# PLANNING COMMISSION REGULAR MEETING

## PLANNING COMMISSION STAFF REPORT

**AGENDA ITEM TITLE:** A. Holman Court Planned Development; and  
B. Holman Court Major Subdivision

# HOLMAN COURT SUBDIVISION

PROJECT: **HOLMAN COURT SUBDIVISION**  
SHEET TITLE: **OVERALL UTILITY**

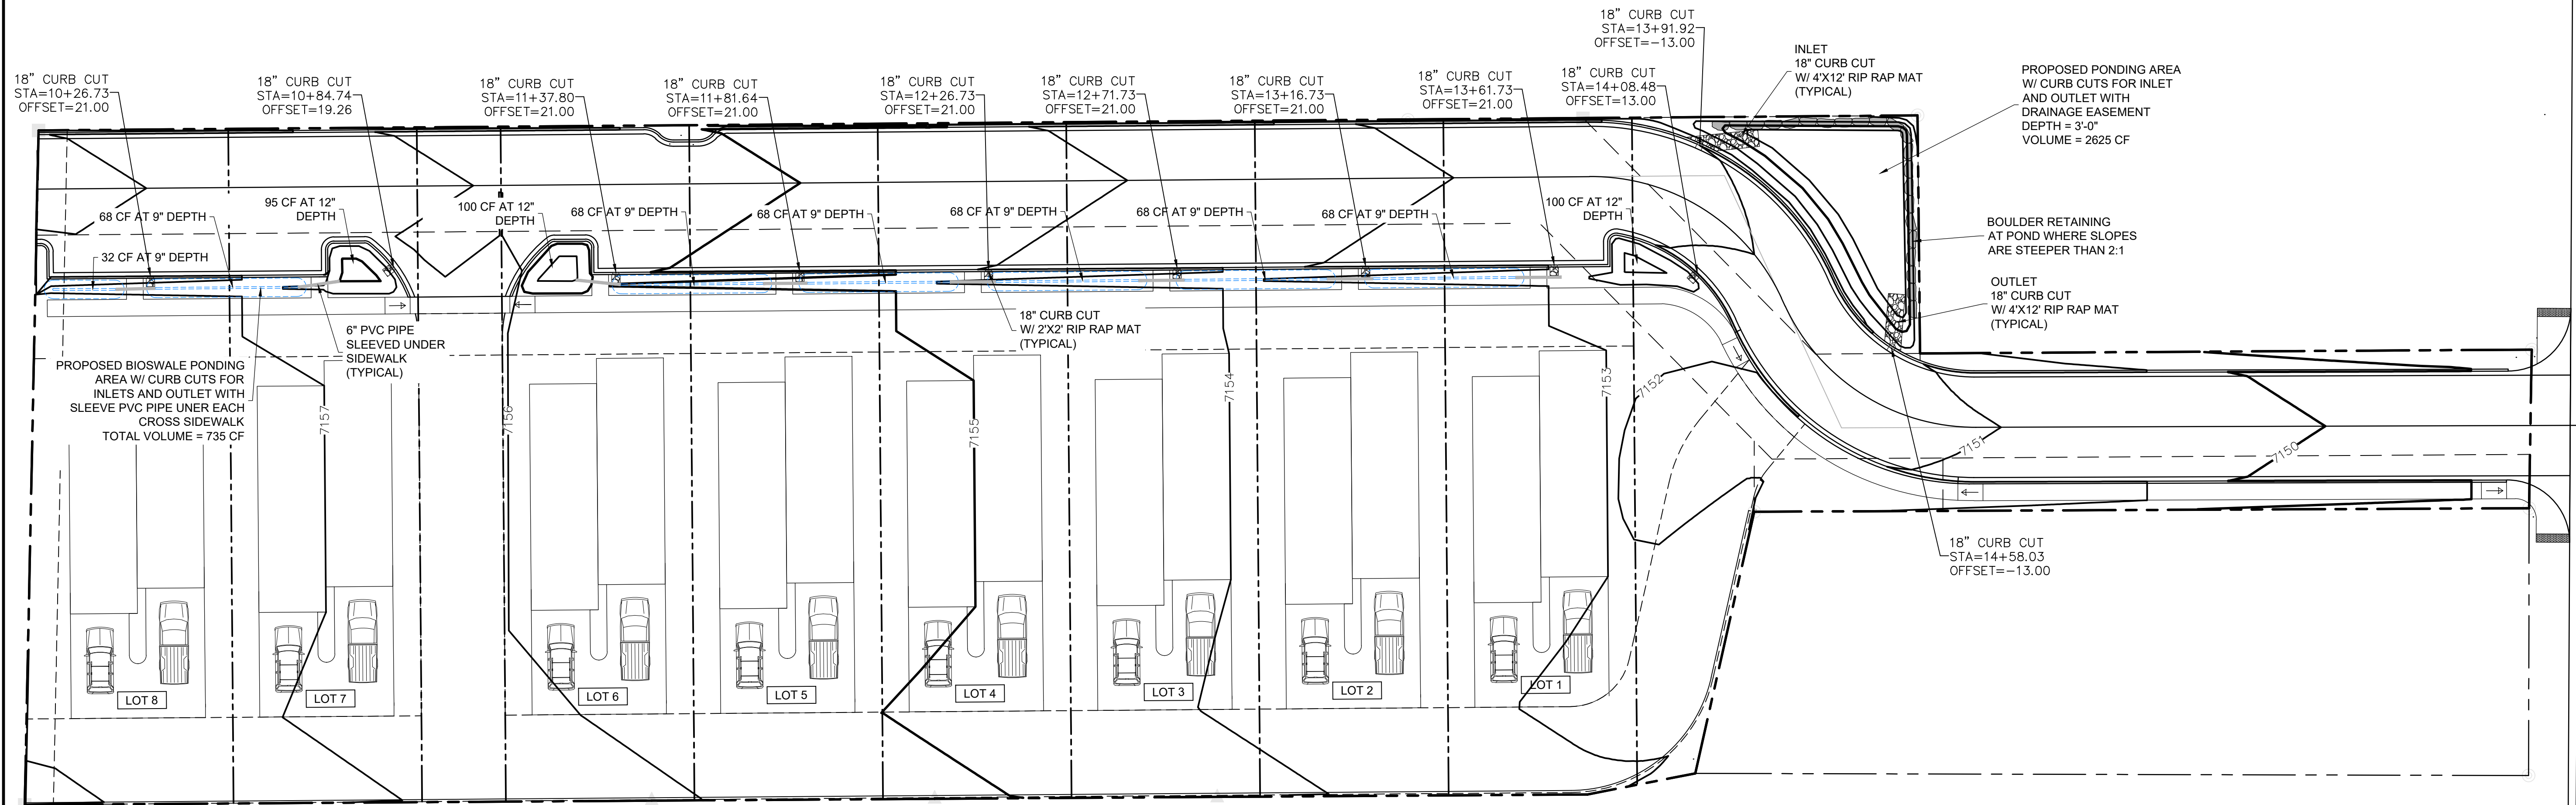
- a. Move fire hydrant to the end of the main to the west. Adjust bump out as needed on the south side.
- b. Put gas/elec other dry utilities on the outside of the wet utilities. Typical section shows them outside of the wet utilities but plan shows them overtop with the call-out ‘may need relocation’.

3. The applicant shall show gas/electric and other “dry” utilities on the outside of the “wet” utilities, prior to final approval.
4. Both affordable units shall be built and receive certificate of occupancy (CO) prior to the tenth unit on the site receiving certificate of occupancy. If the total number of units intended to be built within the PD is reduced below 16, then only one affordable unit shall receive CO (prior to the ninth unit) and the developer will have the choice of either building a second affordable unit next or paying the Inclusionary Housing fee-in-lieu for all units built beyond the affordable unit, prior to each receiving CO.

SHEET TITLE: **PUBLIC WATER**

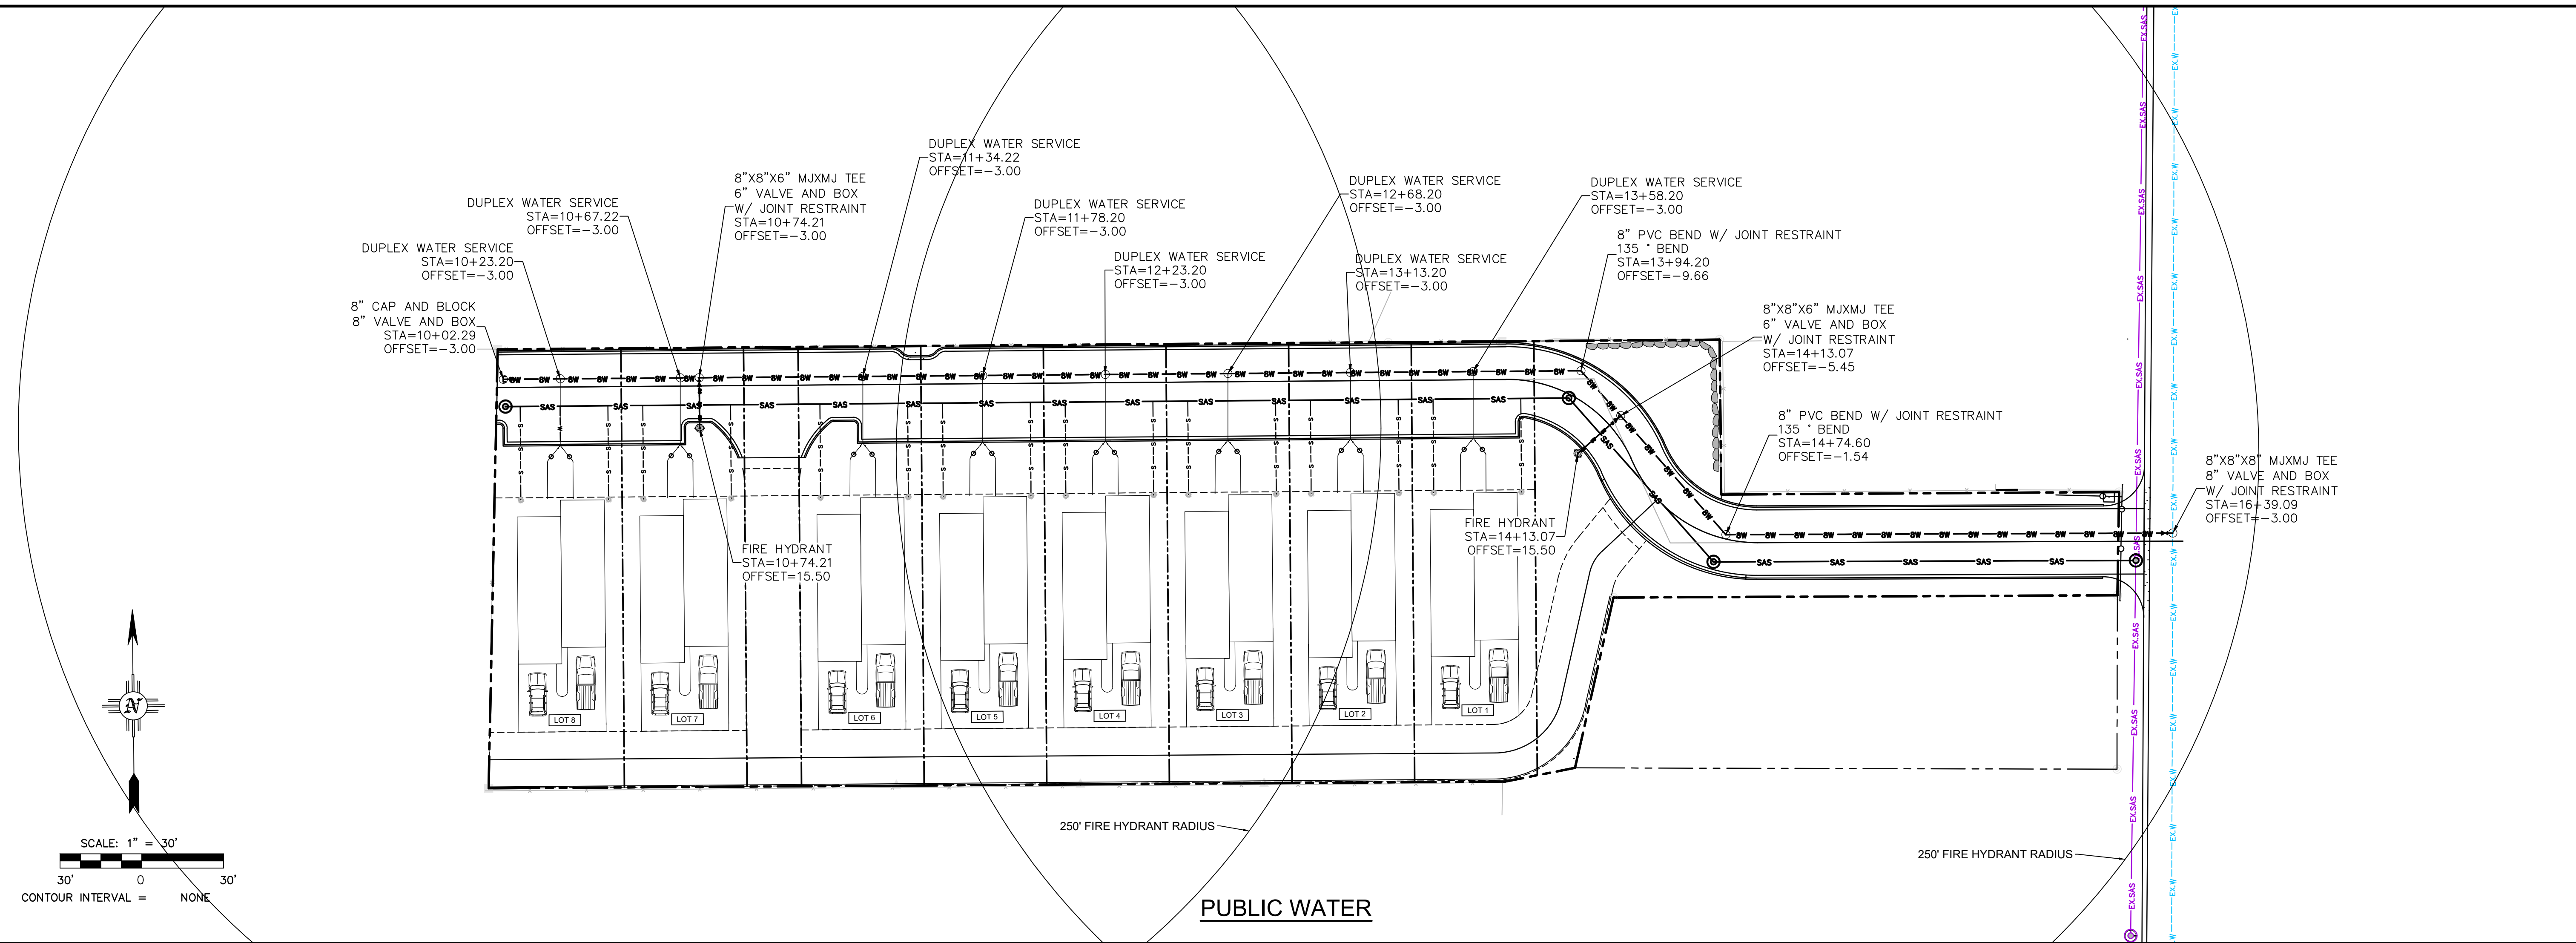
Public Works staff notes the fire hydrant on the west side of the development will need to be relocated to the end of the water main for the project, to allow for proper flushing of the line, and that there are potential issues with the separation of wet and dry utilities as they are shown on the utilities plan. Therefore, staff recommends as conditions of approval:

- The applicant shall show the hydrant at the west end of the development equal with the end of the water main, prior to final approval. The bump out(s) shall be adjusted as needed to accommodate this adjustment.
- The applicant shall show gas/electric and other “dry” utilities on the outside of the “wet” utilities, prior to final approval.

2. The applicant shall show the hydrant at the west end of the development equal with the end of the water main, prior to final approval. The bump out(s) shall be adjusted as needed to accommodate this adjustment.
